Case Name/ Number: RCU2020-00027/HENDERSON PIT RECYCLING

Response to Development Review Team Comments

Date of Comments: 10/23/2020
Project Number: RCU2020-00027
Project Name: Henderson Pit Recycling

SITE PLAN/LANDSCAPE PLAN
HENDERSON GRAVEL PIT
JOB NO. 15694.00
11/20/20
SHEET 1 OF 1

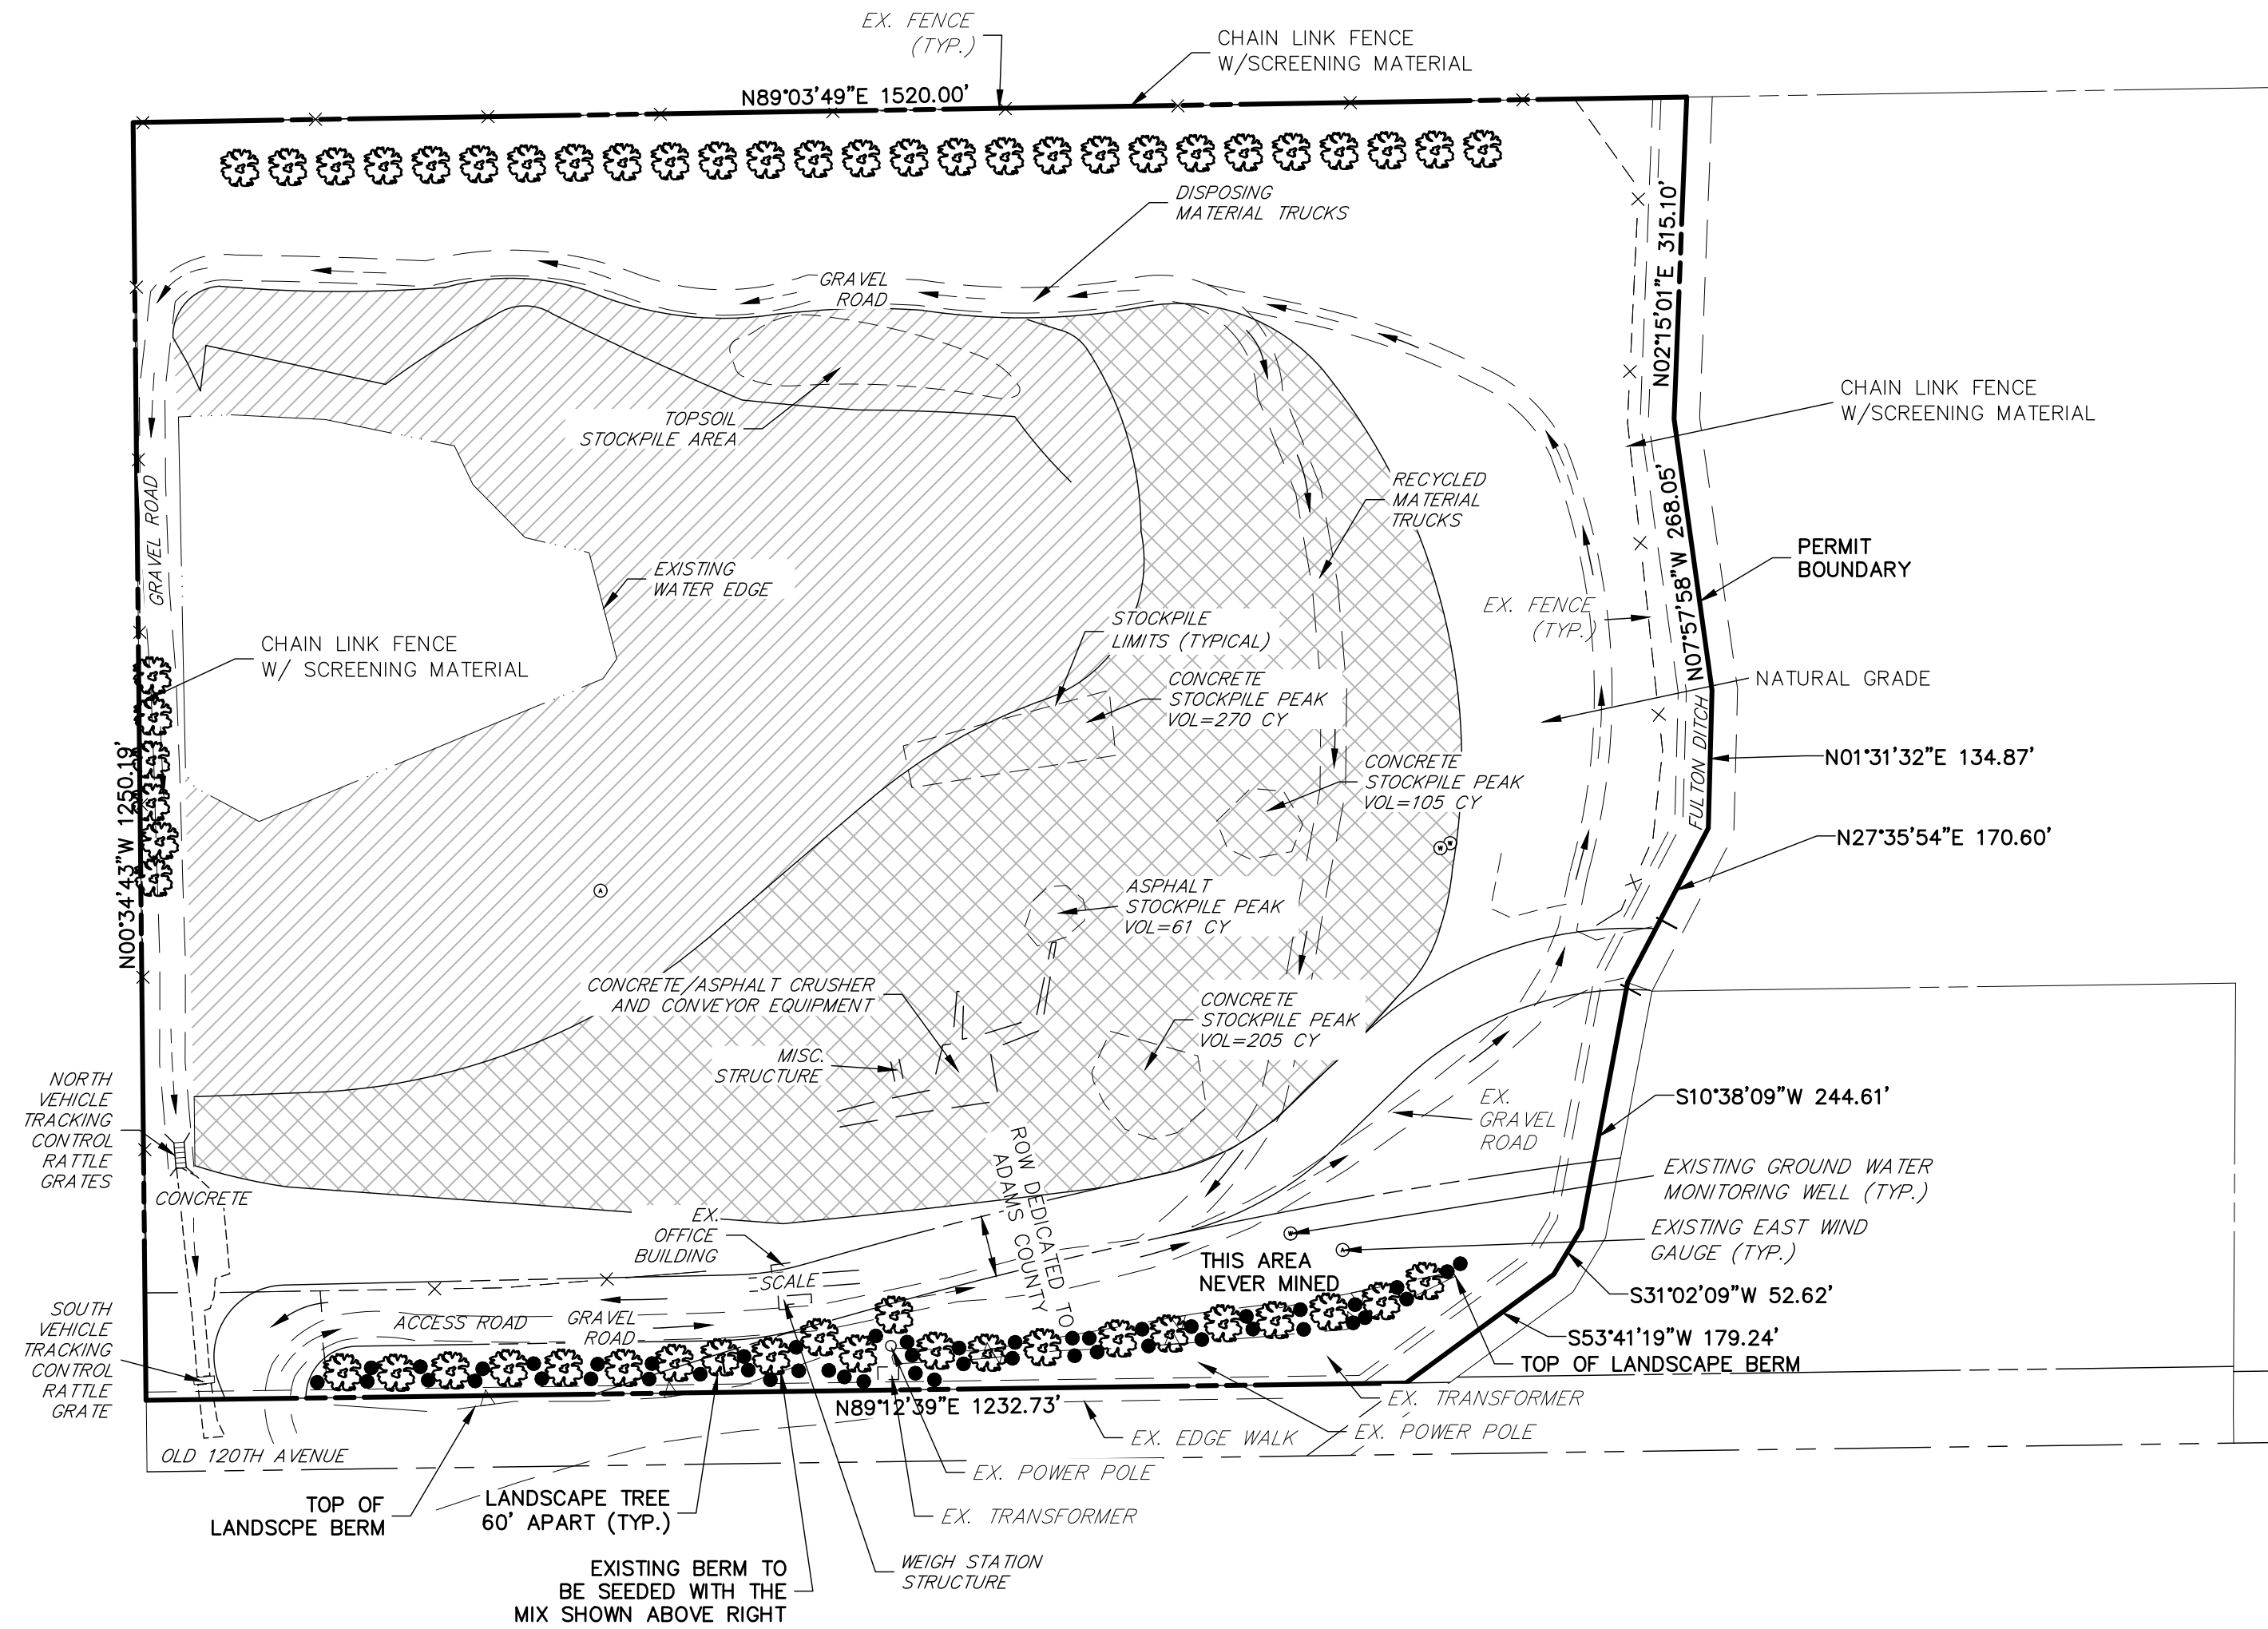
ENV6. The asphalt crusher location is not shown on the site plan. Given this is a listed piece of equipment in the Operations Plan, staff requests the location of such be demonstrated on the site plan.

ENV9. An anemometer, or other type of wind gauge, shall be permanently installed at the location through the duration of the facility's operating life, and shown on the facility Site Plan. When wind gusts exceed 35 mph or sustained winds exceed 20 mph, all crushing operations shall cease. Records of high wind shut downs shall be maintained including date, time and duration.

JR Response: The asphalt and concrete crusher are the same piece of equipment. Site Plan revised for clarity

JR Response: Operations plan updated to ensure records of shutdowns are kept. See site plan for wind gauge locations. See appendices for wind shutdown log and pictures.
